U. S. NUCLEAR REGULATORY COMMISSION
FINAL SAFETY EVALUATION BY THE OFFICE OF NUCLEAR REACTOR REGULATION
FOR THE WESTINGHOUSE ELECTRIC COMPANY TOPICAL REPORT
WCAP-18546-P/NP, “WESTINGHOUSE AXIOM® CLADDING
FOR USE IN PRESSURIZED WATER REACTOR FUEL”
DOCKET NO. 99902038 EPID: L-2021-TOP-0009

Figure 1: PCMI Cladding Failure (Threshold – RXA Cladding at or above 500°F (Ref. 20, RG 1.236))

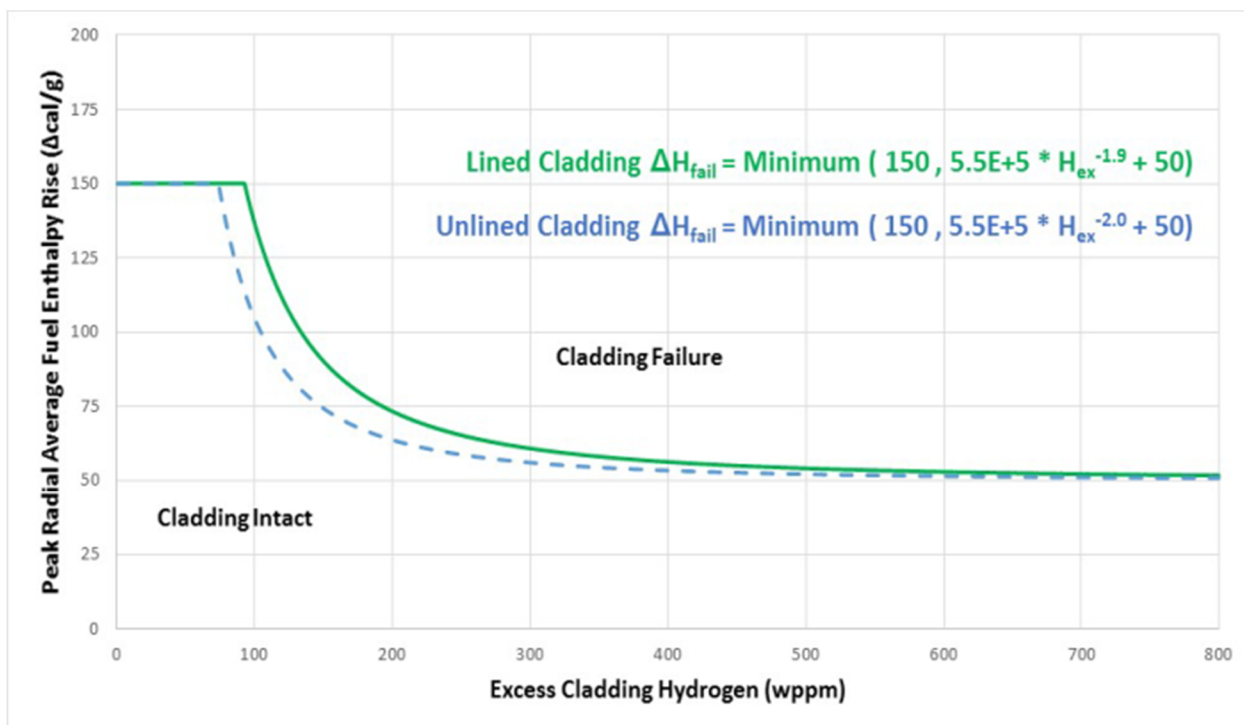
Regulatory Guide (RG) 1.236 (Ref. 20) describes methods and procedures that the NRC staff considers acceptable when analyzing the nuclear reactor's initial response to a postulated control rod ejection accident for PWRs. The REA pellet-cladding mechanical interaction (PCMI)

limit for AXIOM cladding is based on interpolation of SRA and RXA PCMI limits provided in RG 1.236 based on a comparison of radial hydride fractions between SRA ZIRLO cladding, pRXA AXIOM cladding and RXA Low Tin ZIRLO cladding.

RG 1.236 provides the PCMI failure thresholds, peak radial average fuel enthalpy (Cal/g) vs. excess cladding hydrogen at PWR temperatures above 500°F. Figures 1 and 2 (Ref. 20, RG 1.236) show the empirically based PCMI cladding failure thresholds for RXA and SRA cladding materials.

Figure 2: PCMI (Cladding Failure Threshold – SRA Cladding at or above 500°F (Ref. 20, RG 1.236))

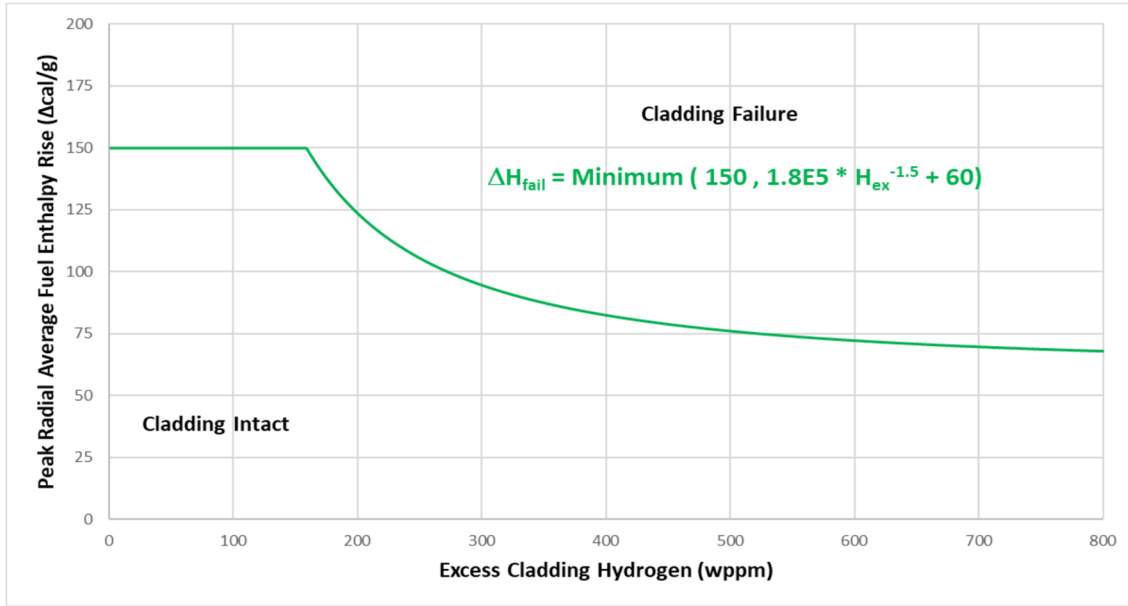
Measurements of radial hydride fraction before and after reorientation treatment from Section 3.10 of the TR were used as input. [

] The average of the two values was chosen to represent AXIOM cladding to interpolate the AXIOM cladding value. Measurements of the radial hydride fraction before and after reorientation treatment from Section 3.10 of the TR were used as input. Figure 3 shows enthalpy increase limit vs. excess hydrogen for SRA cladding pXRA AXIOM cladding and RXA cladding.
